SUBJECT: Forwards remaining responses to NRC 890106 request for addl info re emergency power sys enhancement project.

Re: Turkey Point Units 3 and 4  
Docket Nos. 50-250 and 50-251  
Request for Additional Information on  
Emergency Power System Enhancement Project  
NRC TAC Nos. 69023 and 69024

RESPONSE TO REQUEST FOR ADDITIONAL INFORMATION  
EMERGENCY POWER SYSTEM ENHANCEMENT PROJECT

FIGURE 1-1  
EPS ENHANCEMENT PROJECT  
CIVIL/STRUCTURAL CRITERIA  
(NOT TO SCALE)

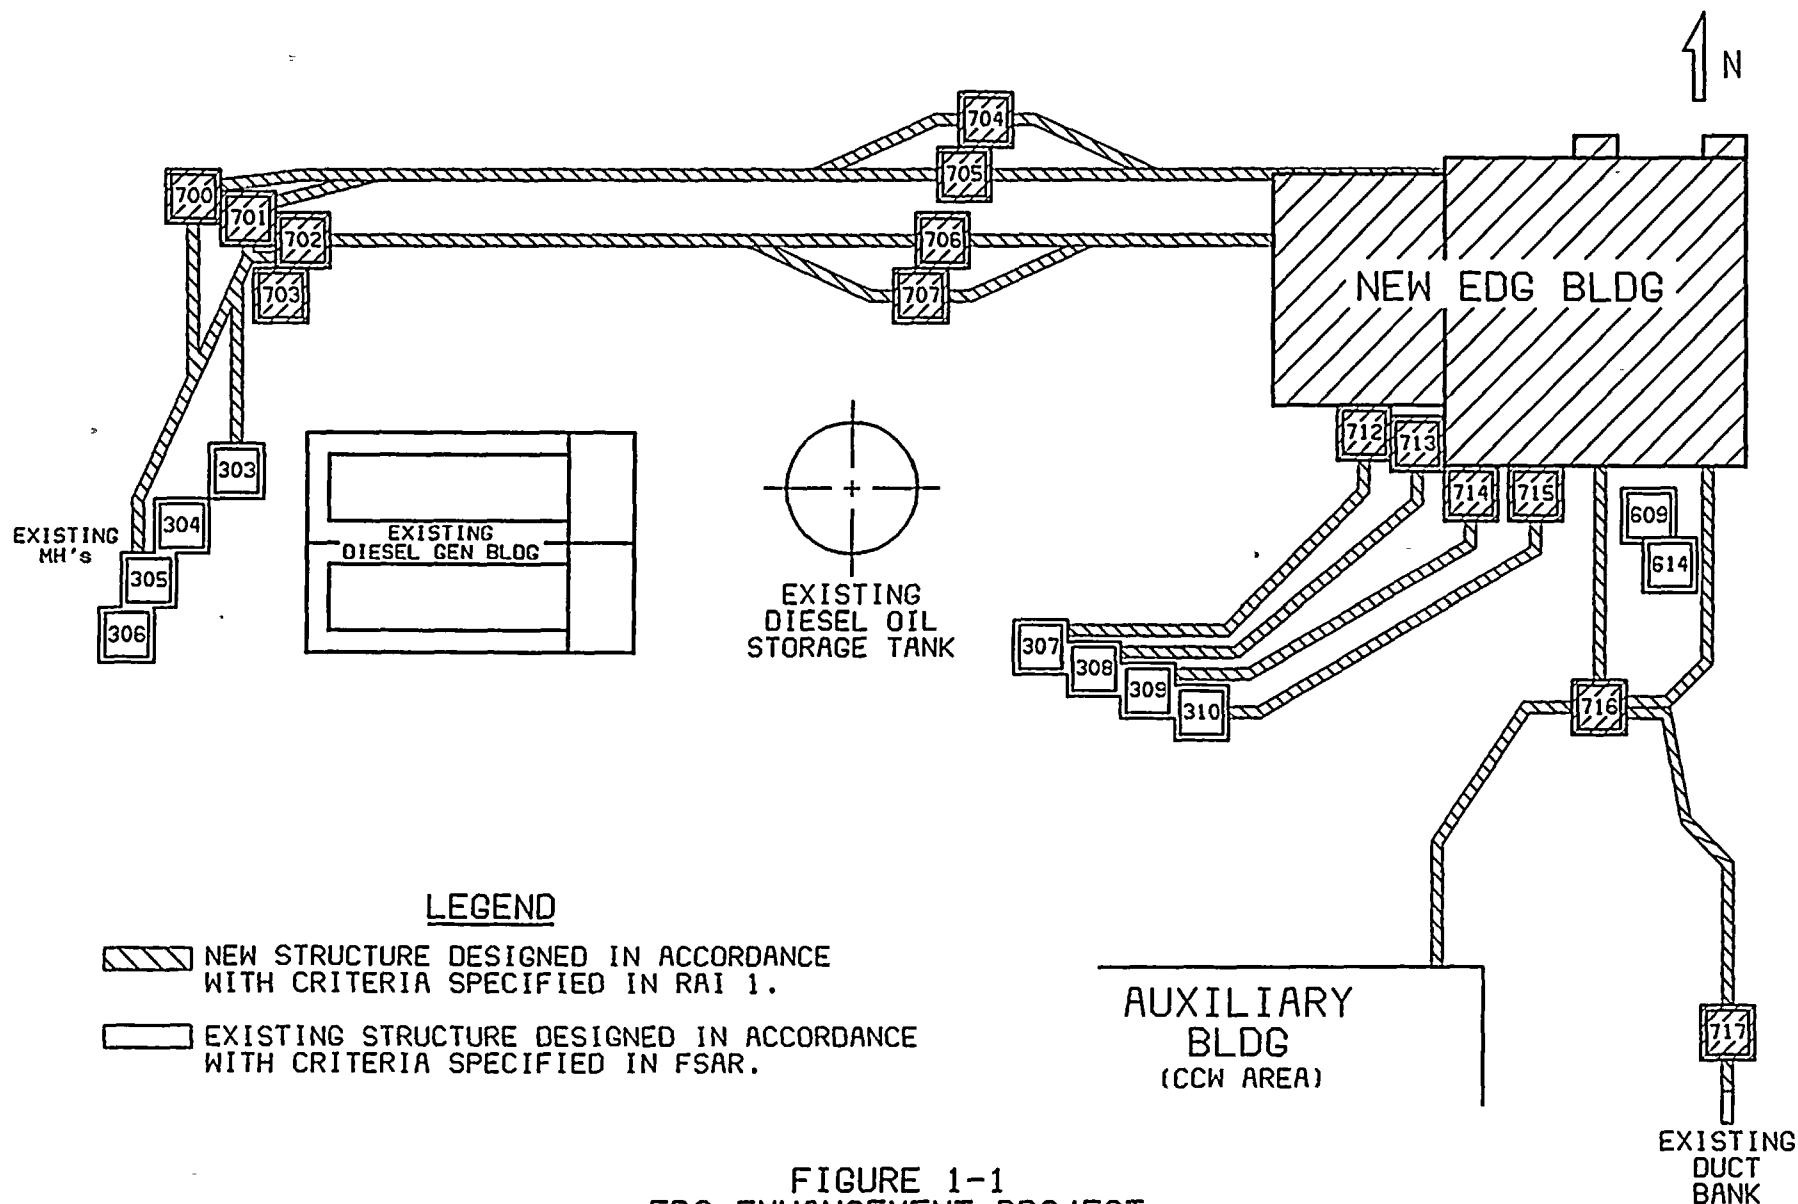
Identify the applicable Codes, Standards, Regulatory Guides, NUREGs, General Design Criteria, Generic Letters, and other documentation (hereafter "Standards") that are to be applied to the system enhancement. For each Standard identified, indicate to which part or parts of the system enhancement that the Standard will apply.

The new EDG building, all internal structures, and all new exterior structures (i.e., ductbanks and manholes) as shown on Figure 1-1 will be designed in accordance with the following criteria. Modifications and additions to existing structures will be designed in accordance with the criteria specified in the FSAR.

Missile protection will be provided for the new EDG building and new exterior ductbanks and manholes shown on Figure 1-1. Missile barriers will be designed to resist penetration and impactive dynamic loading in accordance with the criteria provided in SRP 3.5.3. The following missiles will be considered in barrier design.

FIGURE 32-1  
COOLING SYSTEM HEAT TRANSFER CAPABILITY  
(AT 110% RATED LOAD)

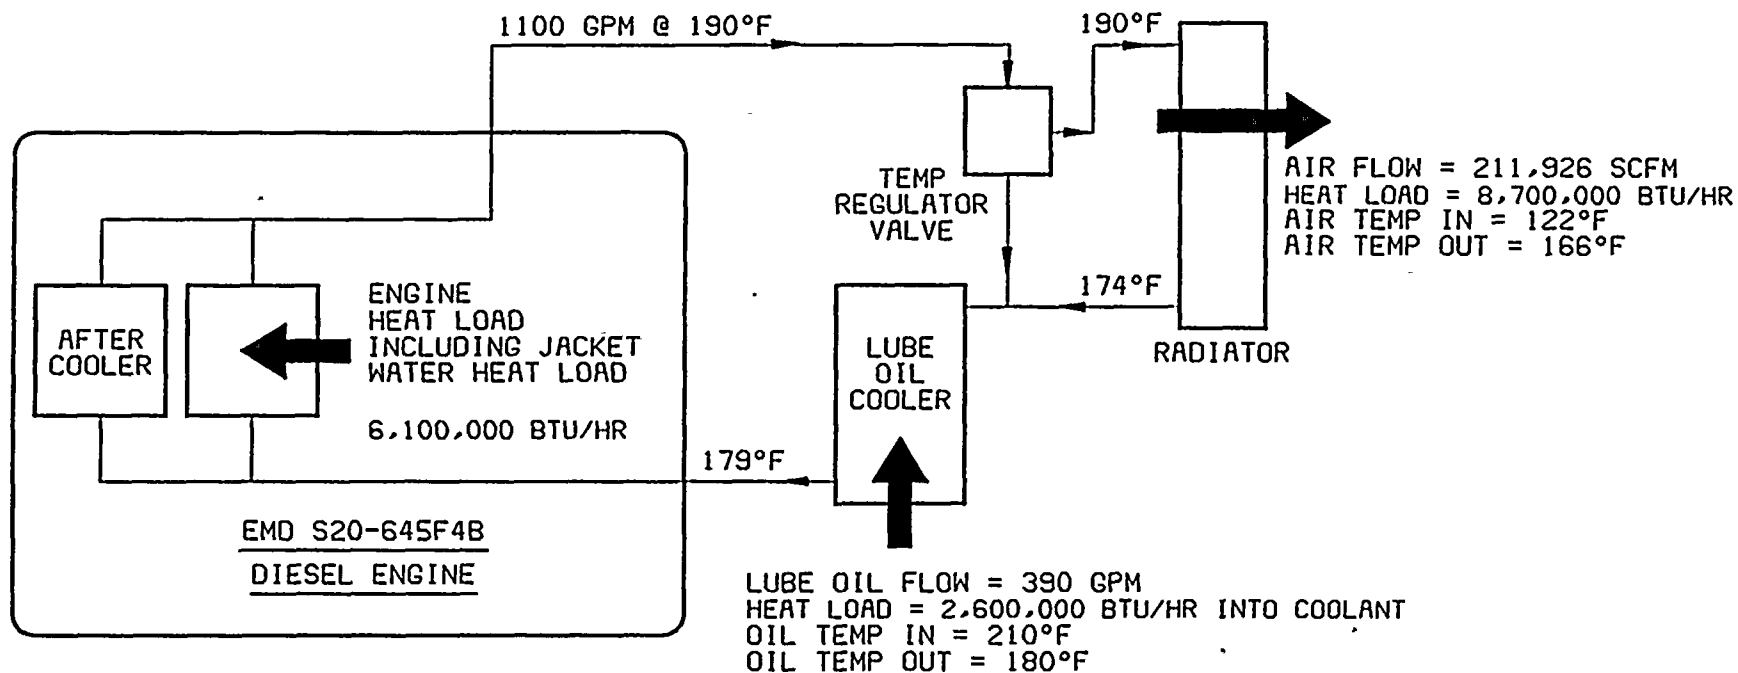
Provide a tabulation showing the individual and total heat removal rates for each major component and subsystem of the diesel generator cooling water system. Discuss the design margin (excess heat removal capability) included in the design of major components and subsystems.

The attached Figure 32-1 identifies the total and individual heat removal rates for the diesel generator cooling water system at 110 percent rated load. The cooling system is designed to maintain a top tank (water leaving the engine) temperature of 190°F at 110 percent rated load and radiator cooling air entering the radiator coils at 122°F. Since the engine is typically not operated at 110 percent rated load, the actual heat removal requirements are lower. The lower actual heat load constitutes design margin for the system.

FIGURE 37-1  
TYPICAL COOLING SYSTEM SCHEMATIC WITH RADIATOR

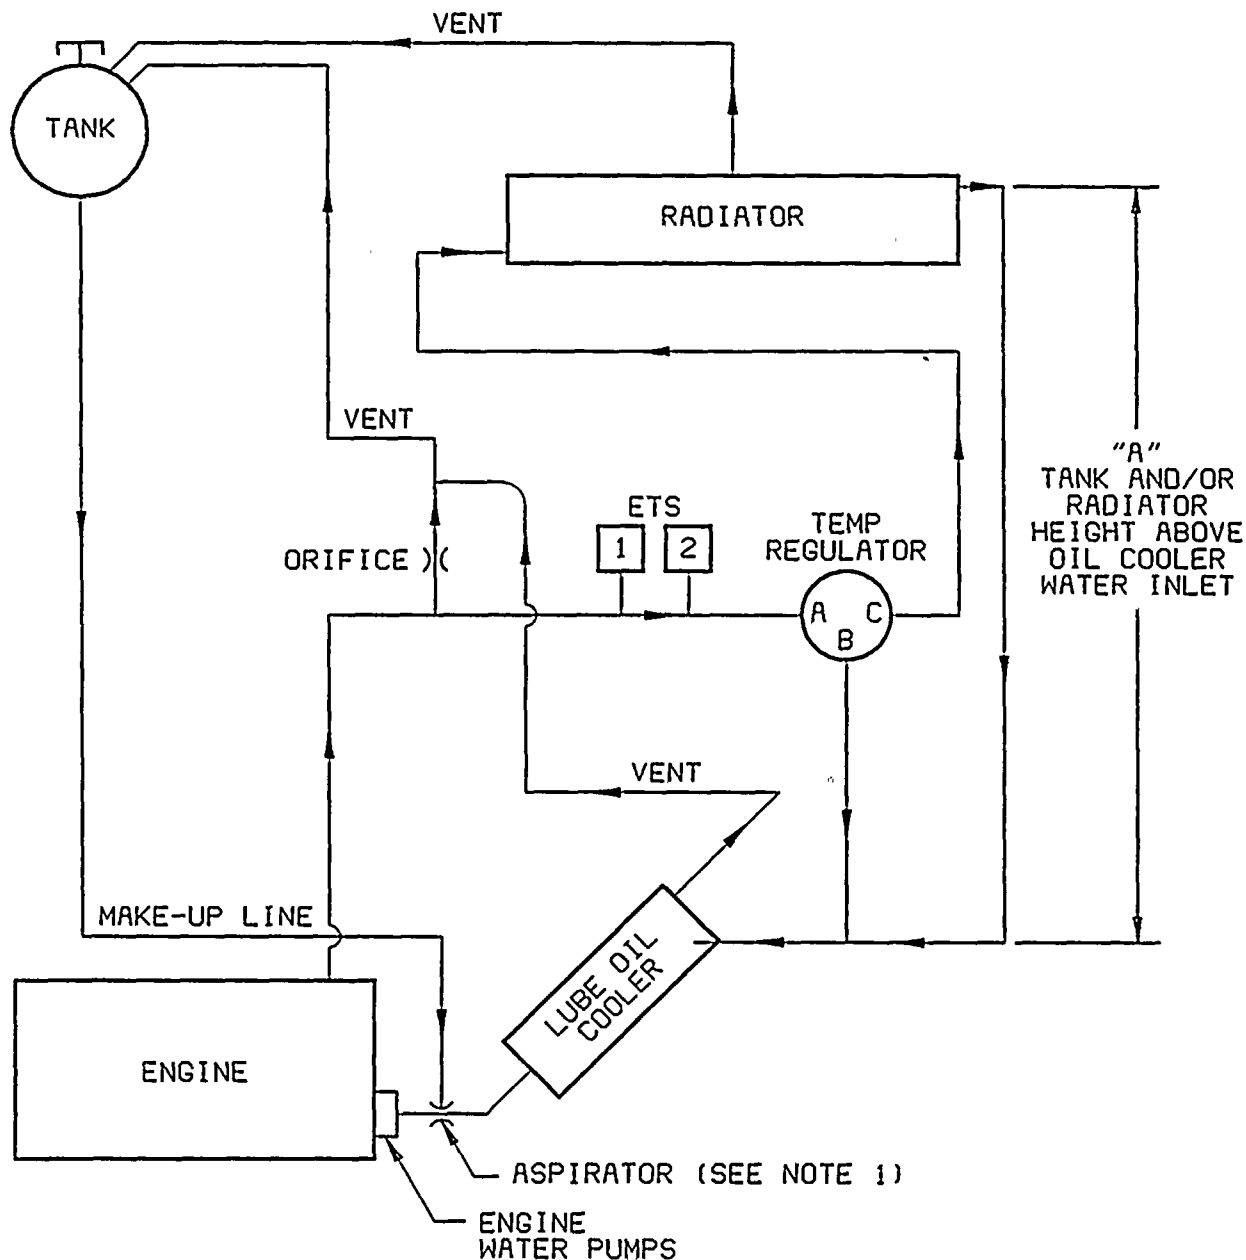
Describe the provisions made in the design of the diesel engine cooling water system to assure that all components and piping are filled with water.

- 1) The minimum height of the expansion tank and radiator relative to the water inlet connection to the lube oil cooler should be 15 feet. Any less height would require the use of aspirators (see Figure 37-1).
- 2) The maximum height of the expansion tank and radiator relative to the water inlet connection to the lube oil cooler should be 25 feet.

- 3) The total pressure loss of pipe and cooling equipment external to the engine accessory rack should be limited to 8 psi.
- 4) To assure that the cooling system is kept completely full of water, the high points of any pipe or component shall be vented to the top of the expansion tank (see Figure 37-1).

The new EDG's comply with each of the above requirements.
